ADDENDUM 2

CSP 22-68

Memorial Middle School Heating & Air Condition (HVAC) Improvements Funded through the Elementary & Secondary Emergency Relief (ESSER) Funds

April 8, 2022

DBR
 9990 Richmond Avenue, South Building, Suite 300
 Houston, Texas 77042
 713.914.0888 p 713.914.0888 f
 TBPE Firm Registration No. 2234
 DBR Project Number 218007.002
 HA JA JB --- --

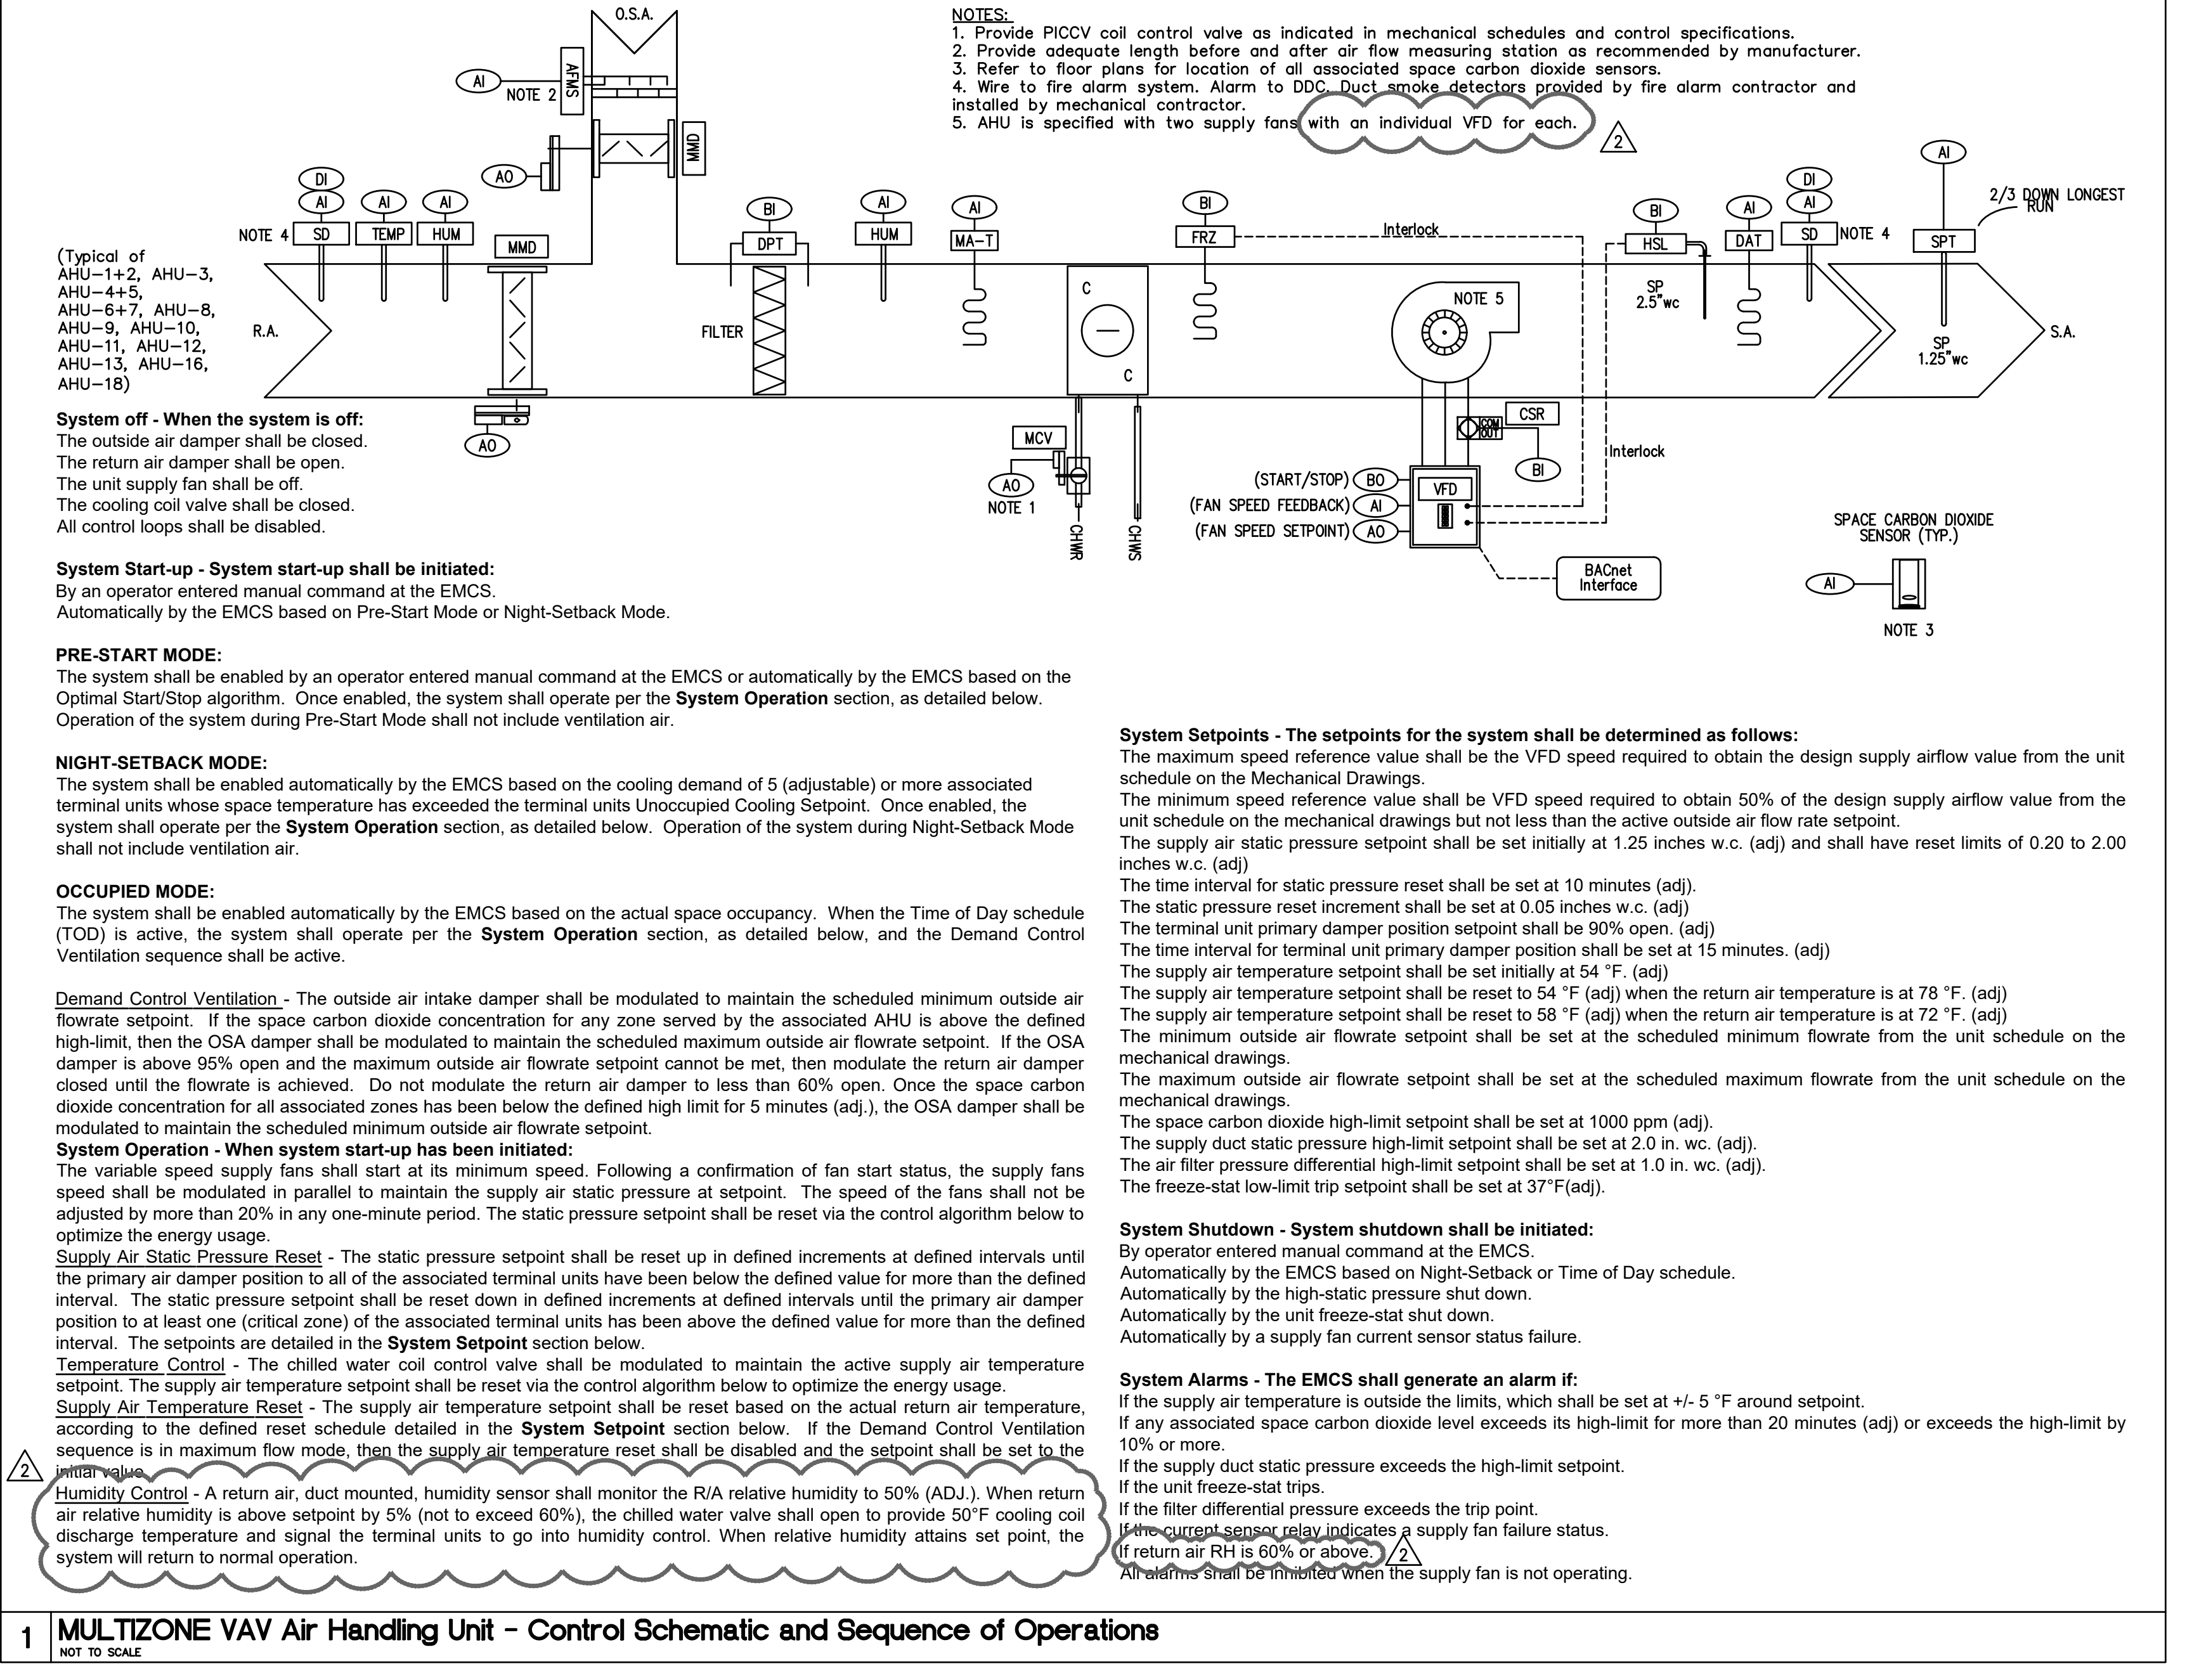
Item 15 SHEET M4.02 – MECHANICAL CONTROLS

A. Revised Single Zone VAV Air Handling Unit – Control Schematic and Sequence of Operations.
B. Revised Multi Zone VAV Air Handling Unit – Control Schematic and Sequence of Operations.

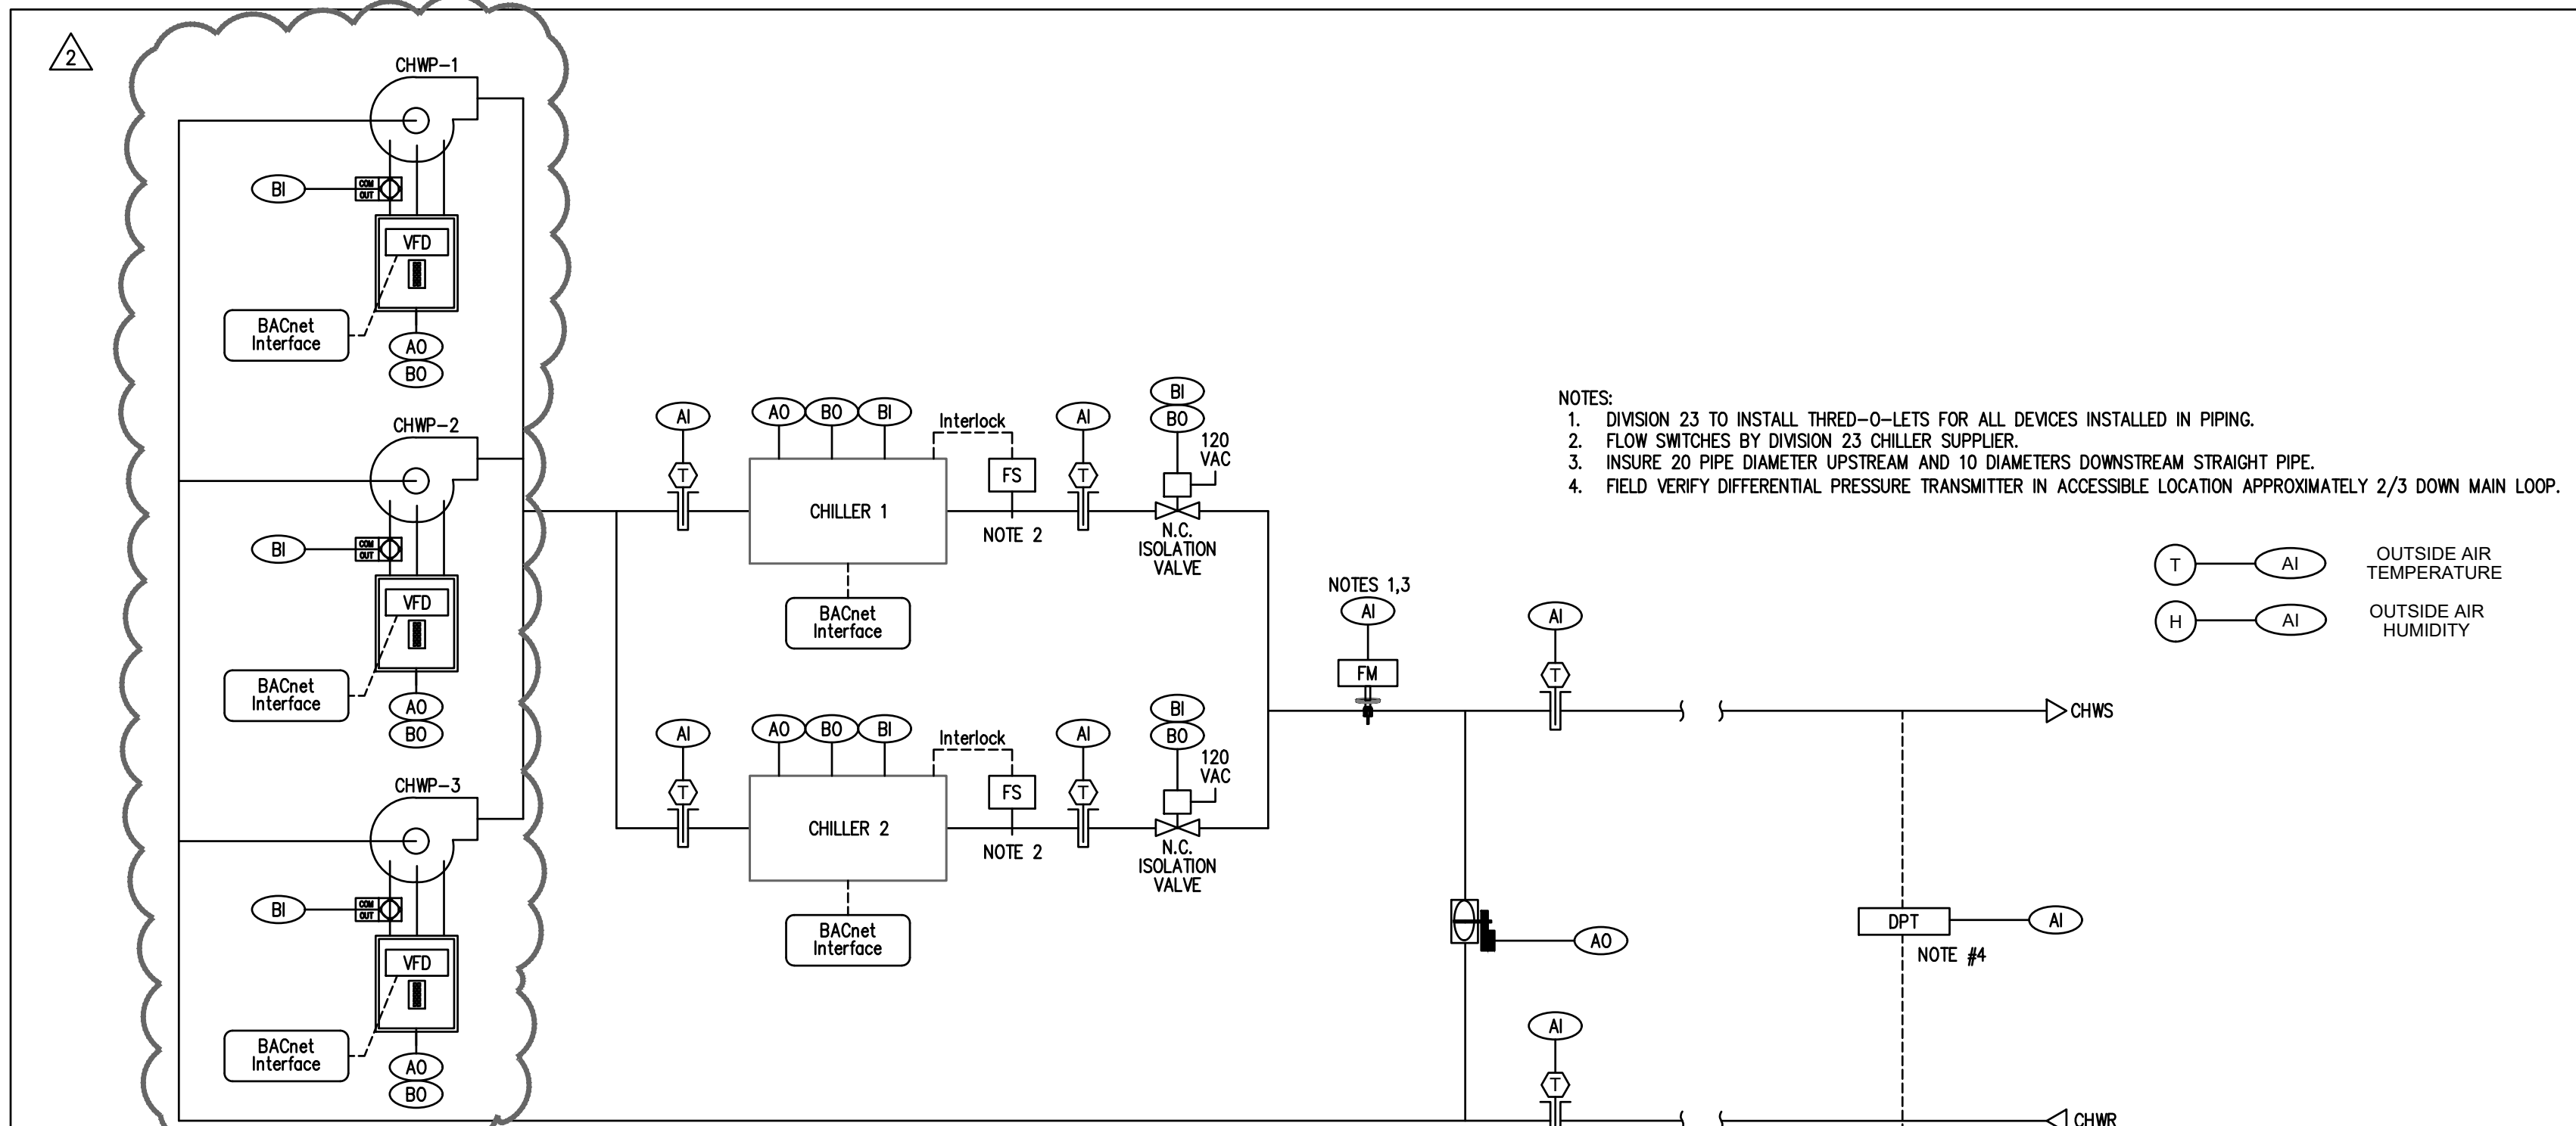
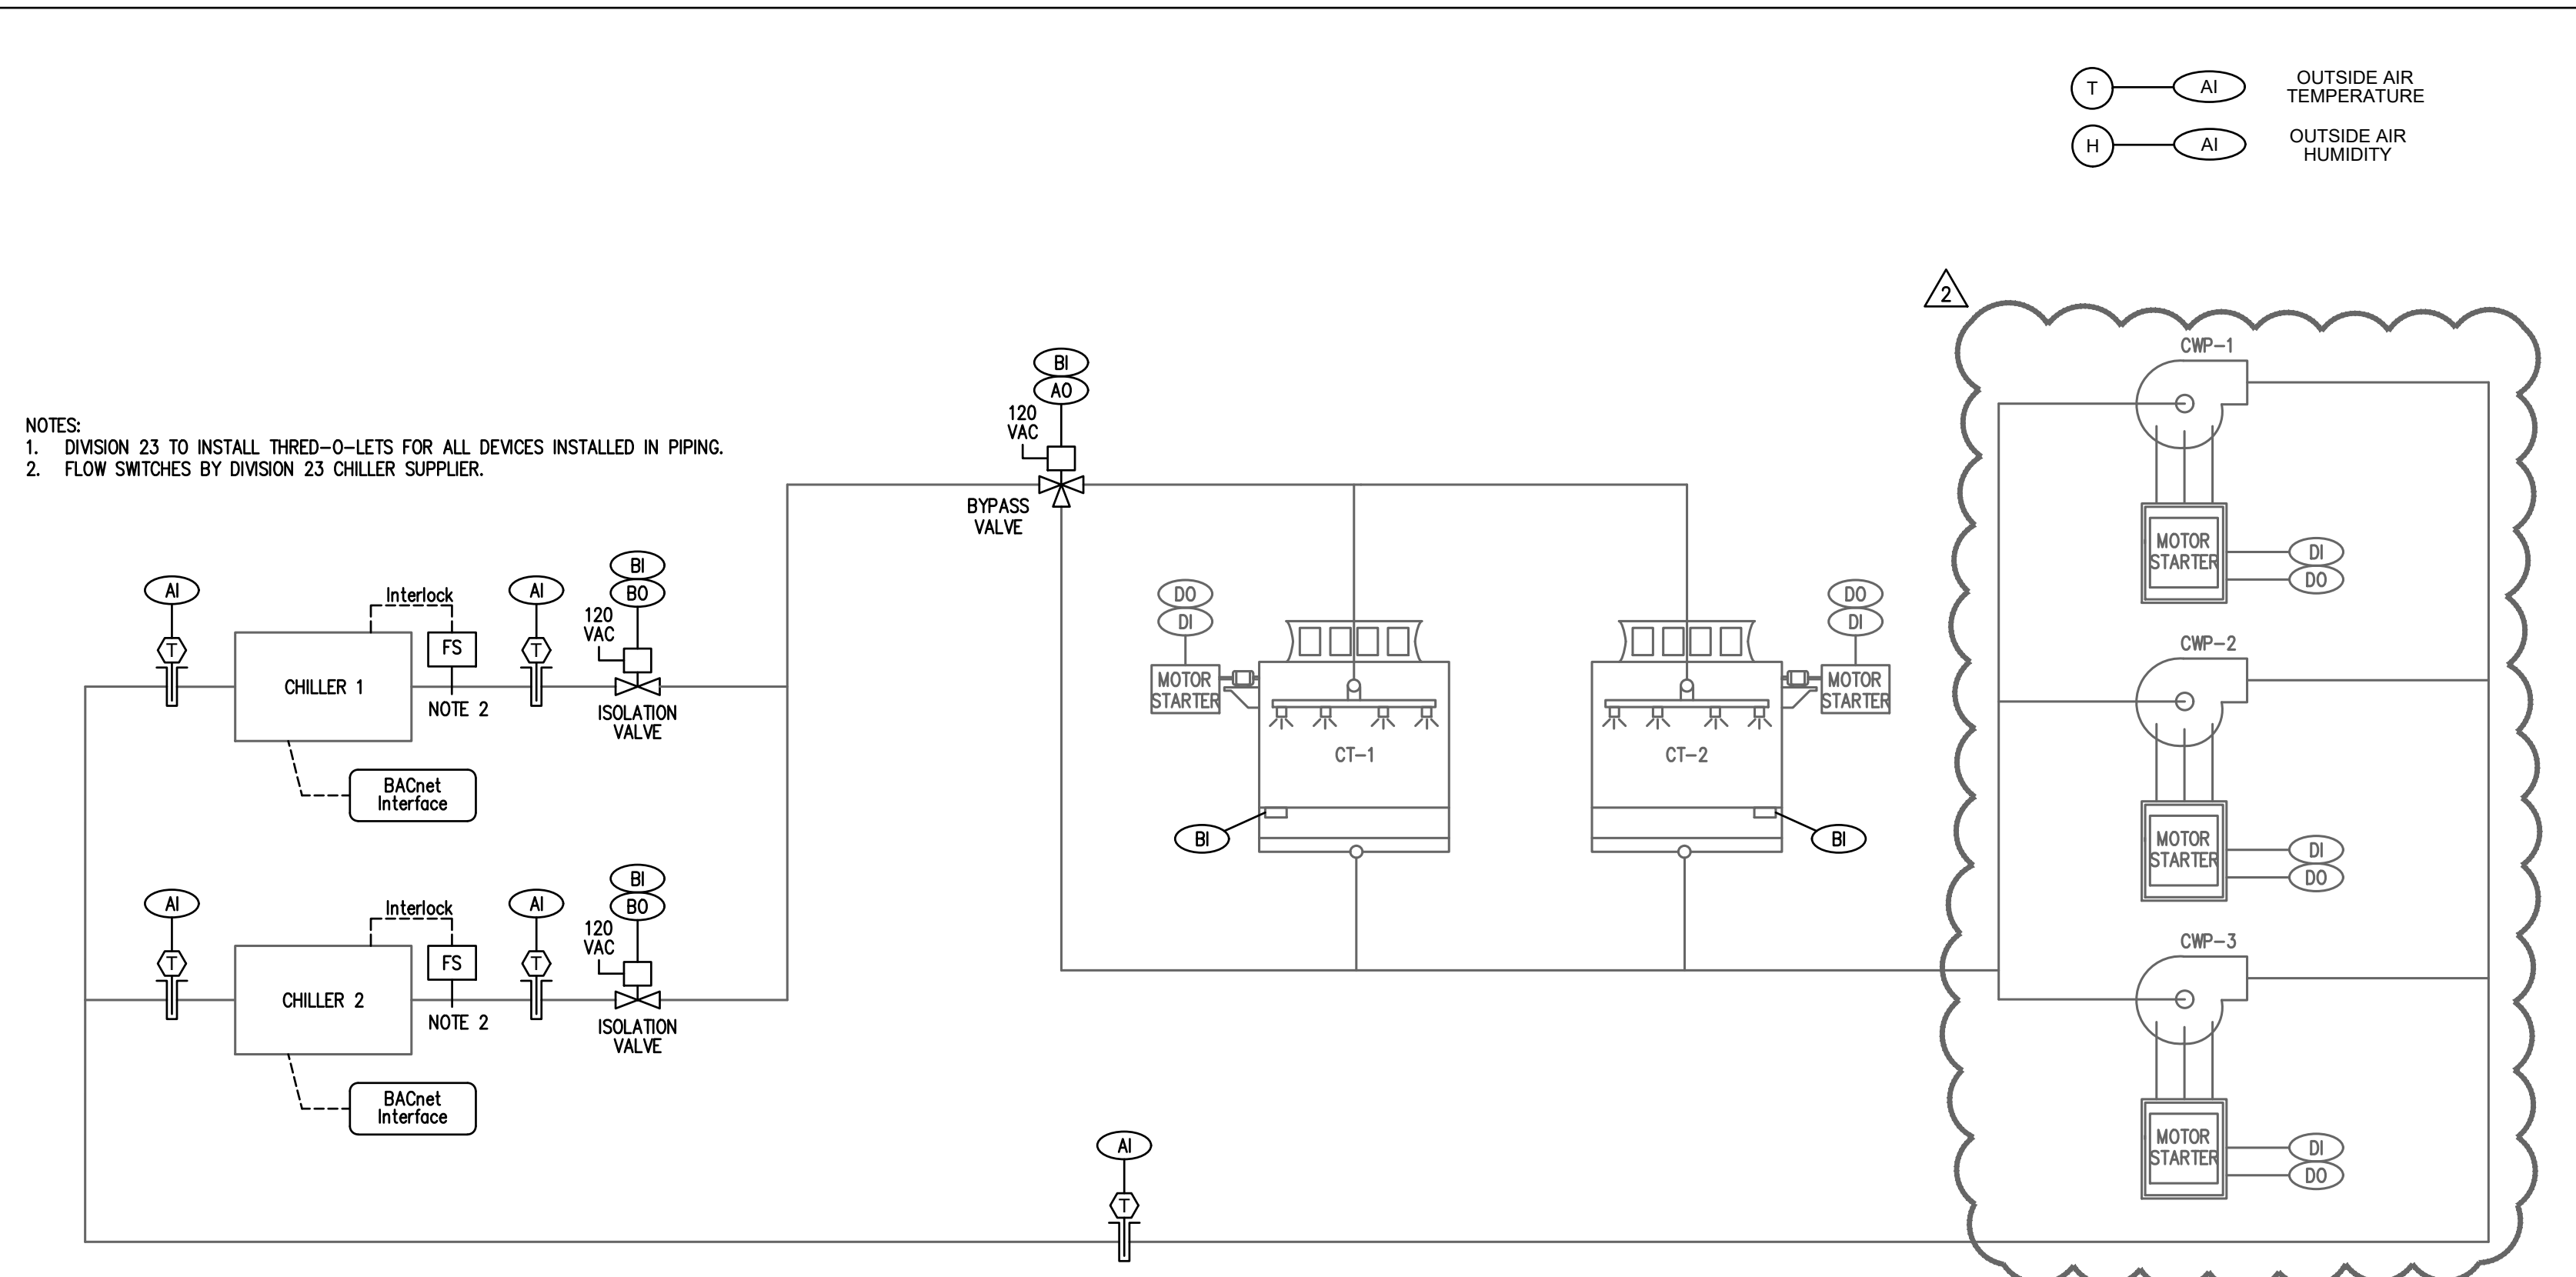
Item 16 SHEET M4.03 – MECHANICAL CONTROLS

A. Revised Chilled Water System – Variable Primary Flow – Control Schematic Sequence of Operations
B. Revised Condenser Water System – Chiller Plant – Control Schematic and Sequence of Operations

System Off - When the system is off:
 The chillers shall be off.
 The pumps shall be off.
 The bypass valve shall be closed.
 The chiller isolation valves shall be closed.
 The control loops shall be disabled.

When a chiller is to be disabled, the EMCS shall discontinue the command for the chiller to run. The EMCS shall continue to hold open the chiller isolation valve until the chiller status has indicated that it is off. Then the EMCS shall close the valve.
